# CITY OF ALBUQUERQUE

December 26, 2018

**Re: Sandia View Cottonwood**  
**10401 Vista Del Sol Dr. NW 87114**  
**Traffic Circulation Layout**  
Engineer's/Architect's Stamp 12-10-18 (A13D023)

SHEET NUMBER: TCL-101

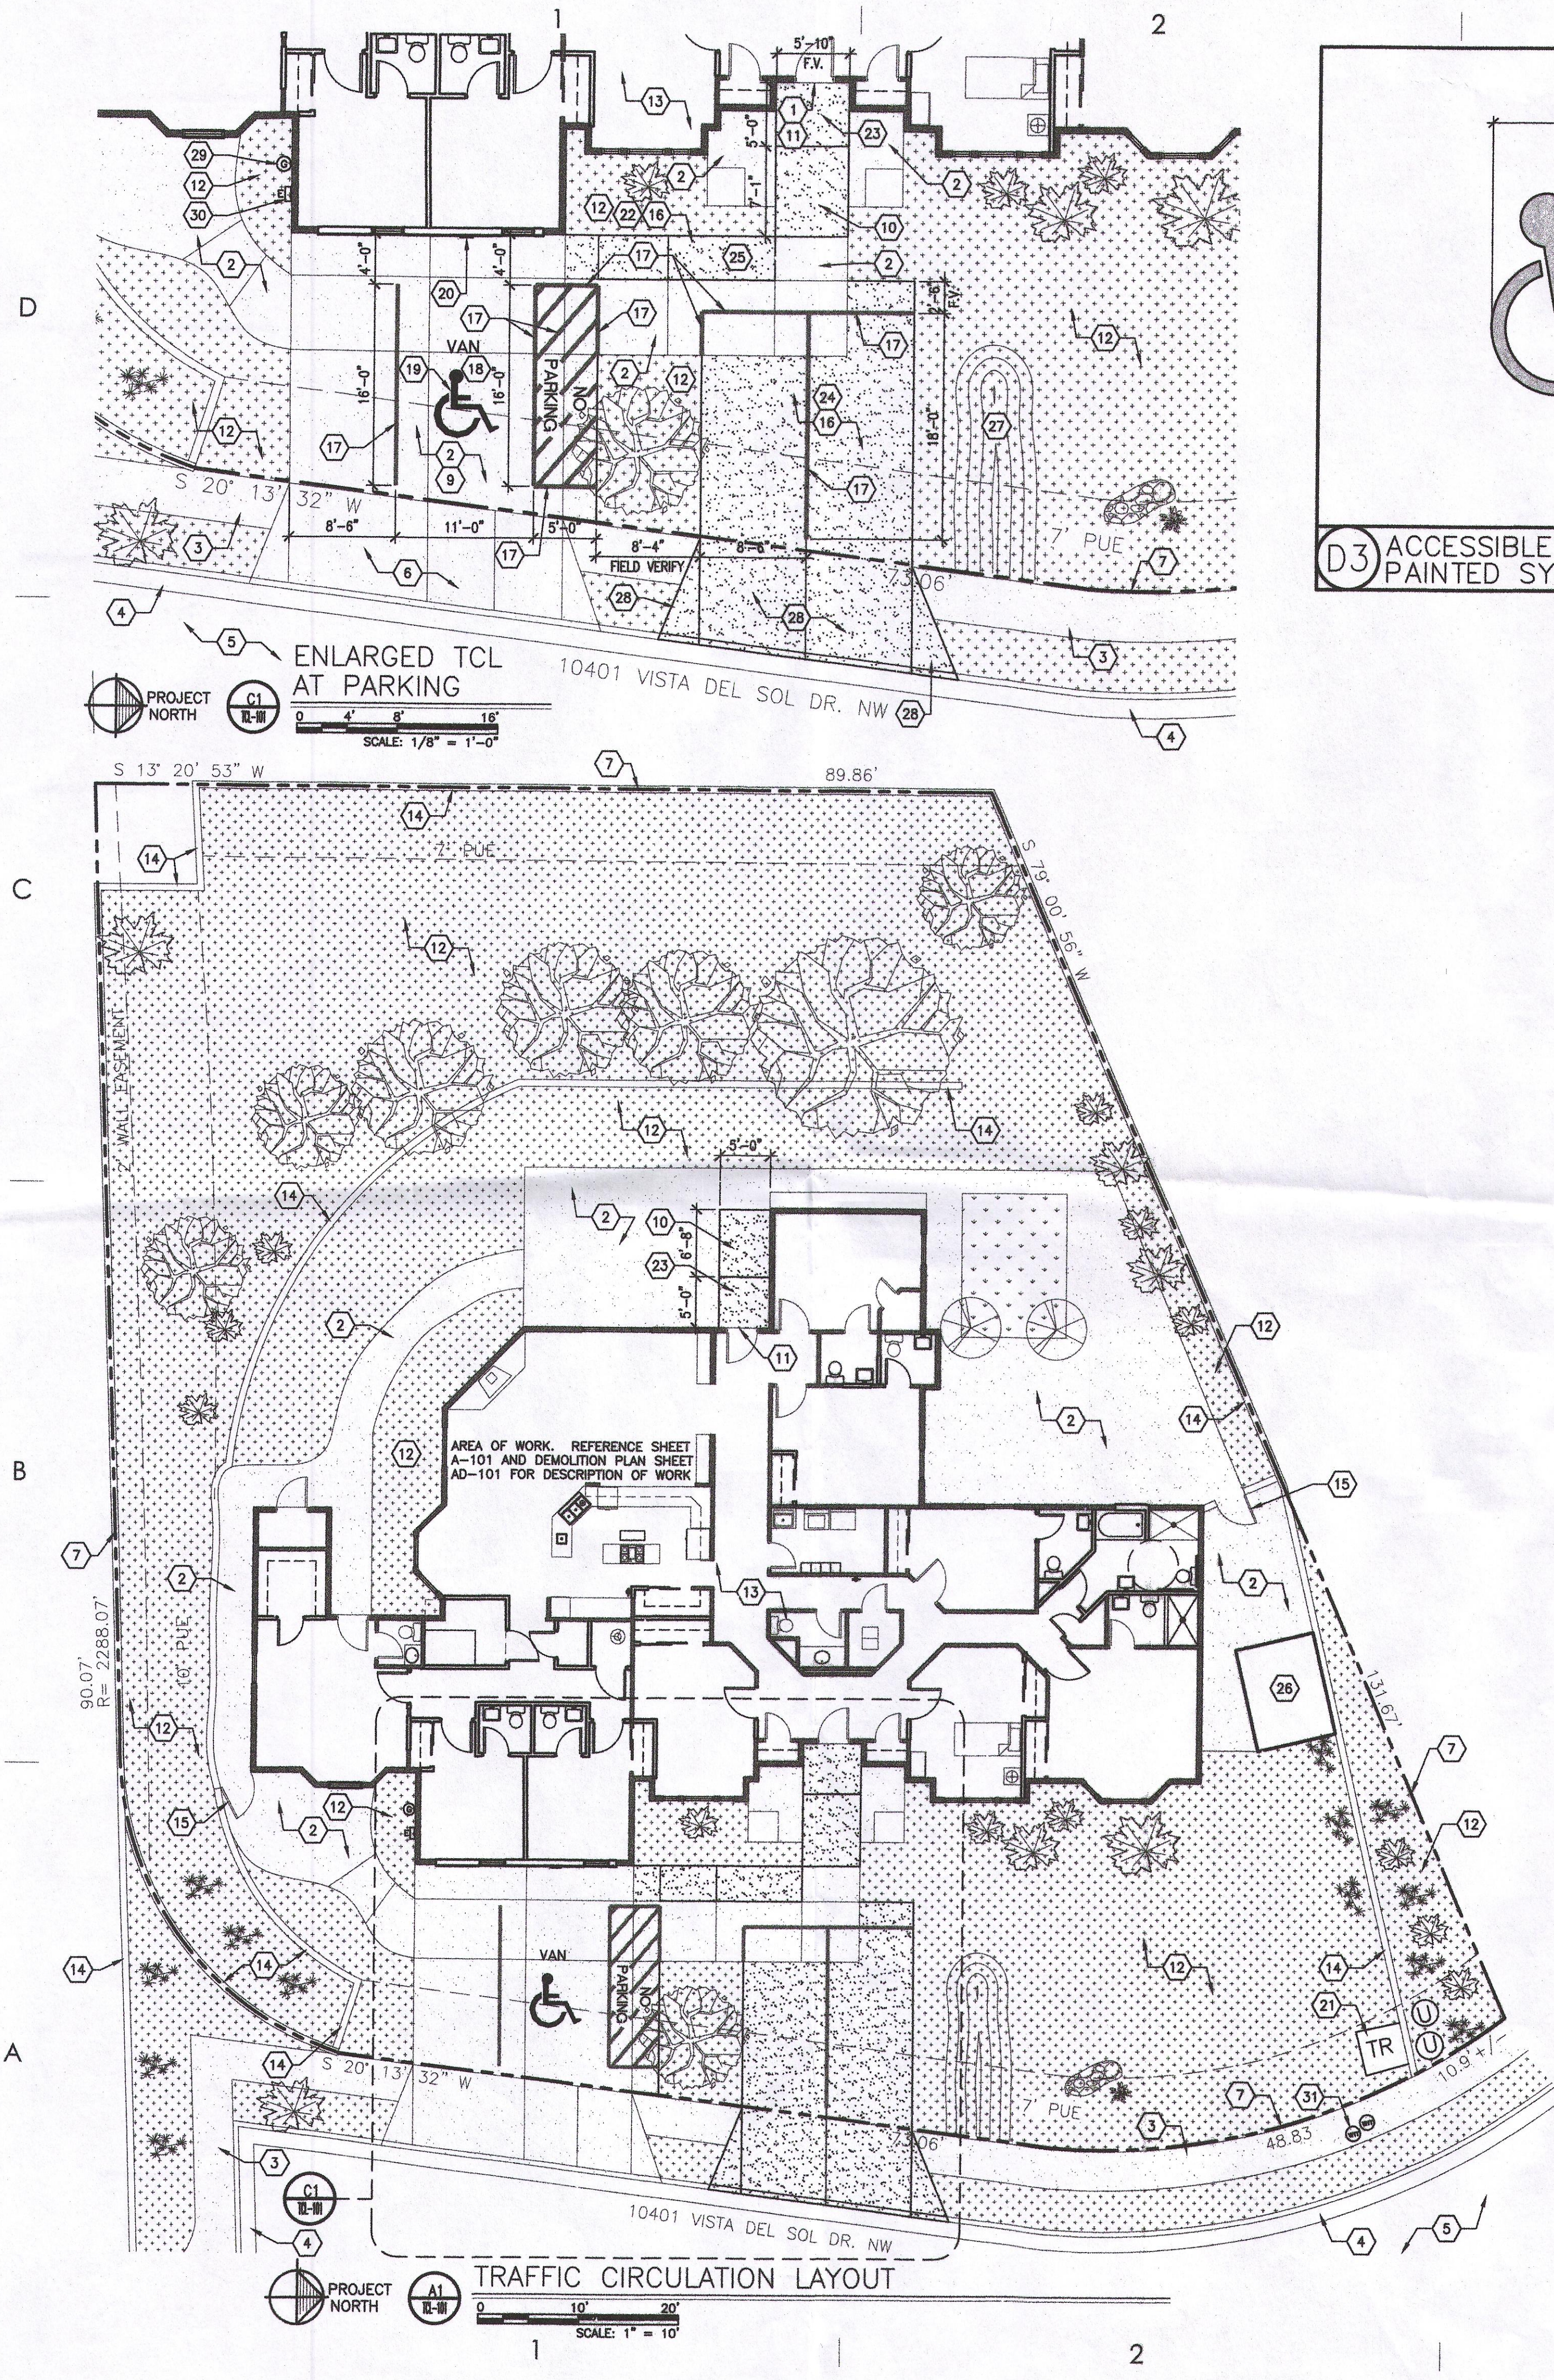
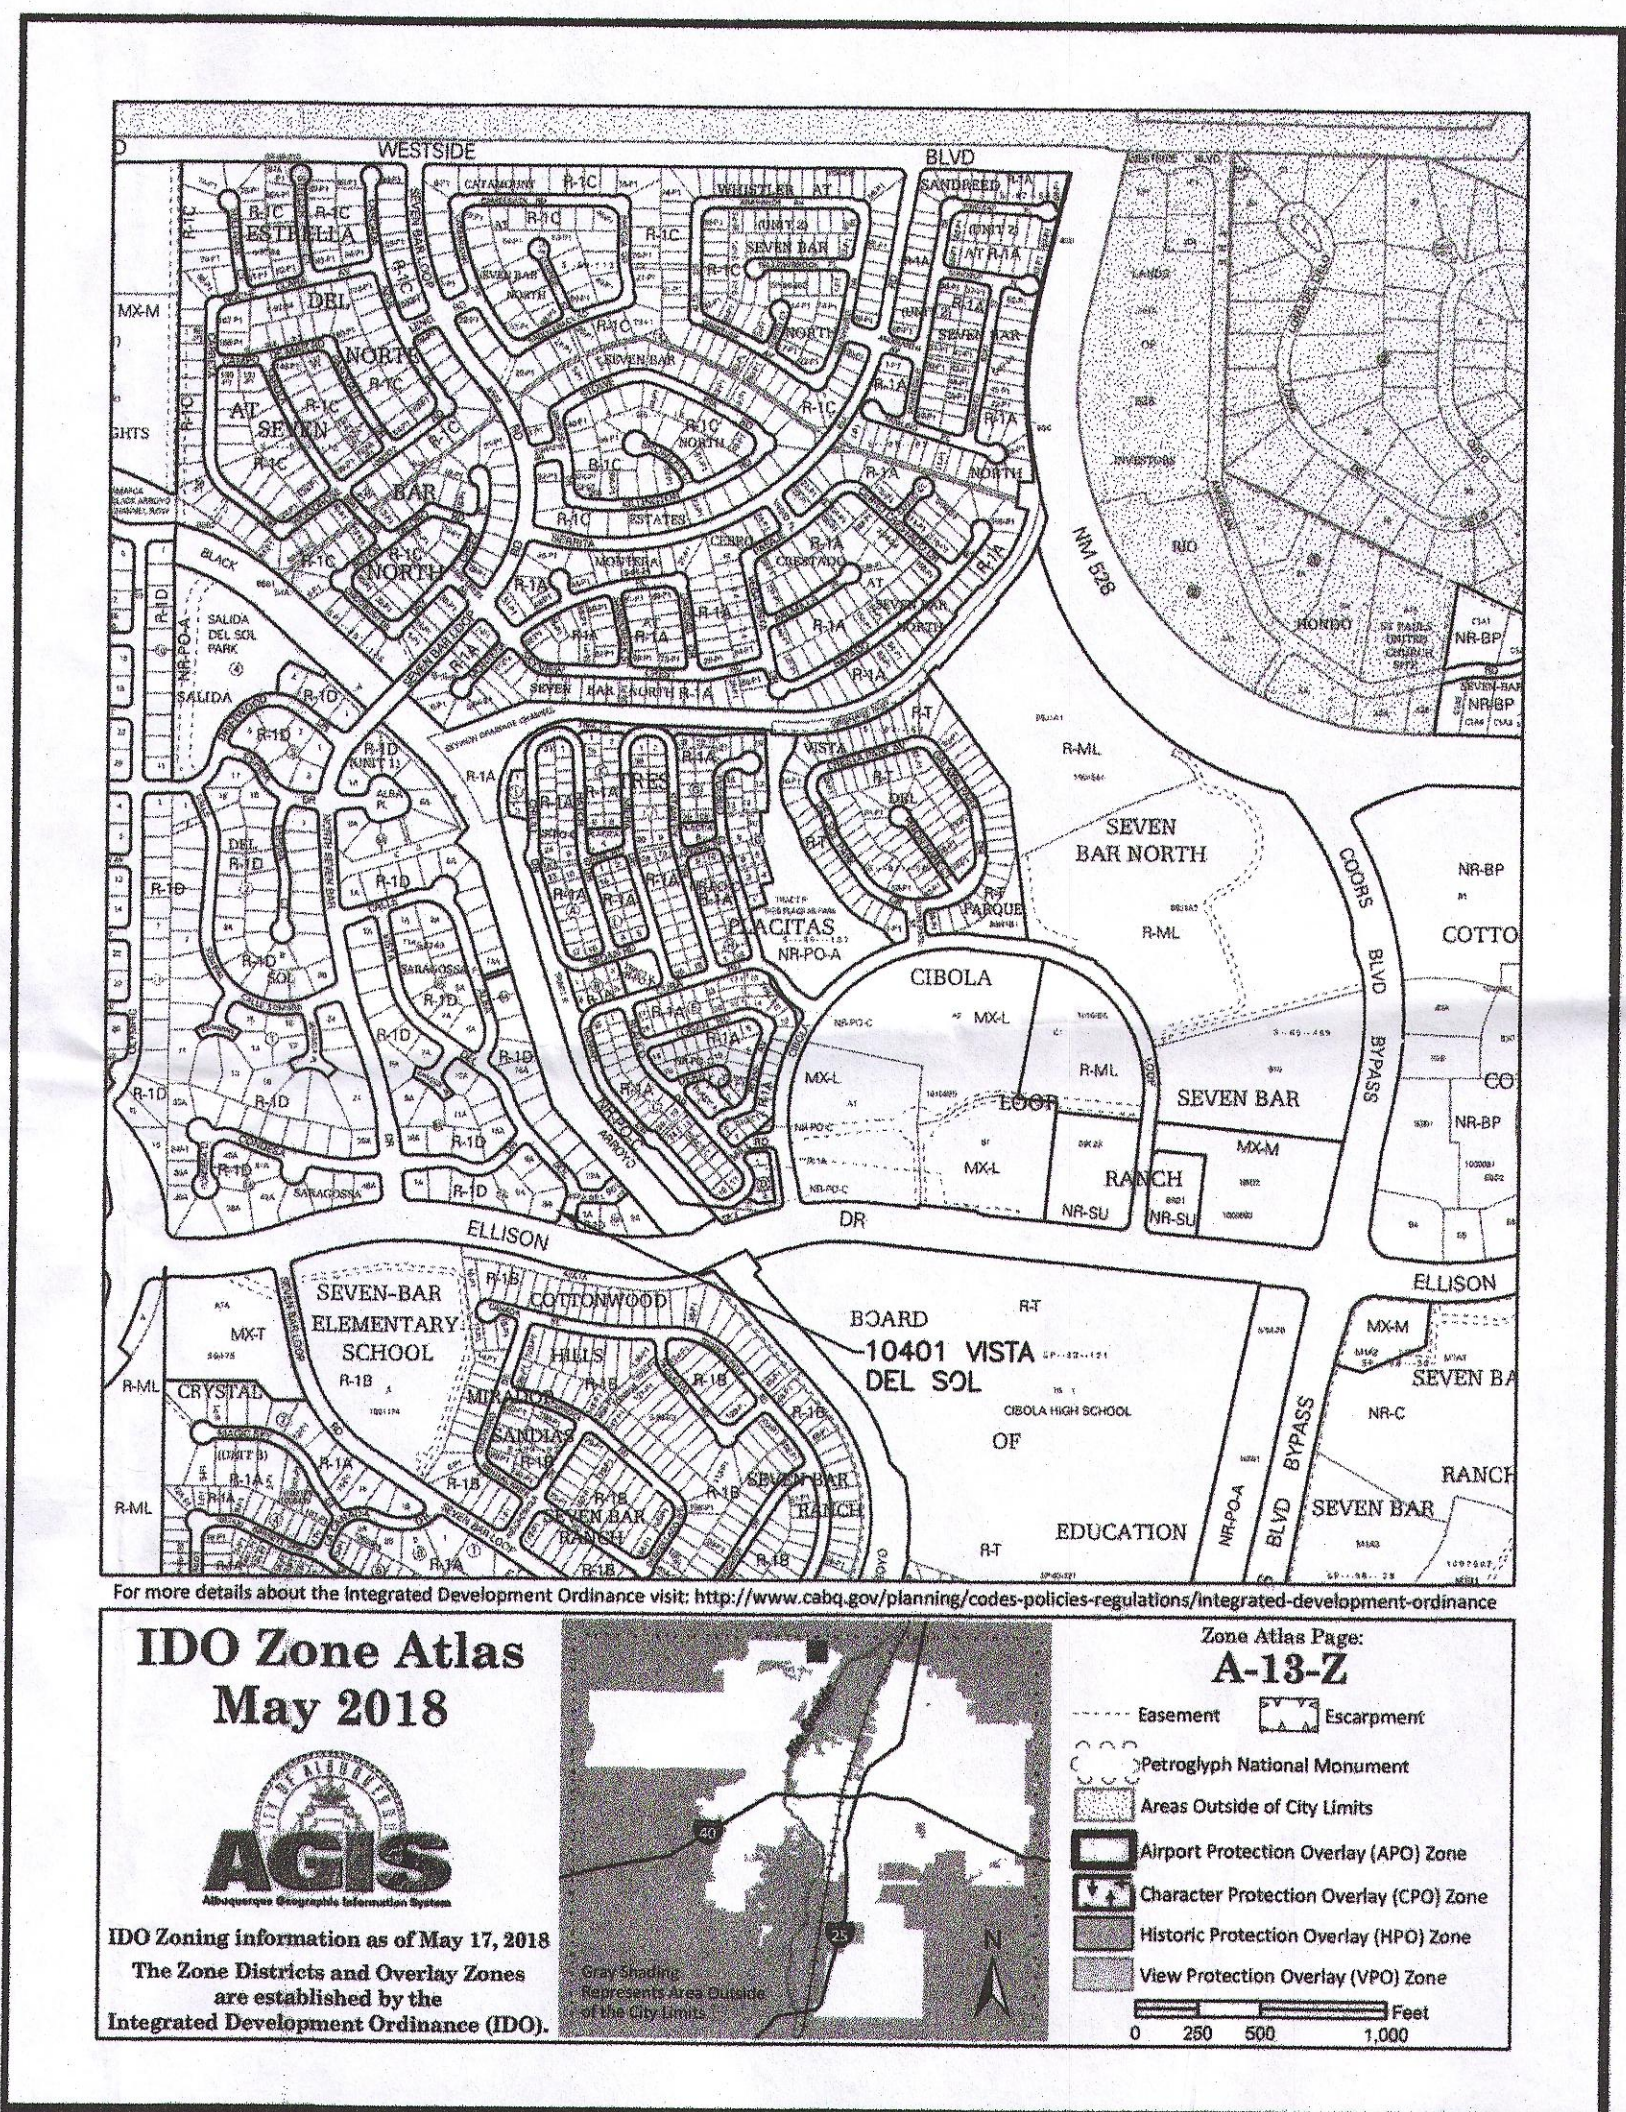
1. The ADA access aisles shall have the words **"NO PARKING"** in capital letters, each of which shall be at least one foot high and at least two inches wide, placed at the rear of the parking space so as to be close to where an adjacent vehicle's rear tire would be placed. (66-1-4.1.B NMSA 1978)
2. The minimum distance between two drives on one lot is 22' of full height curb. ( 6' is necessary for two curb height transitions for a total of 28' between the two drive pads. ( The width of drive allowed is 12' to 22") Please dimension width of drive pad.
3. Please include one copy of the traffic circulation layout at the next submittal.
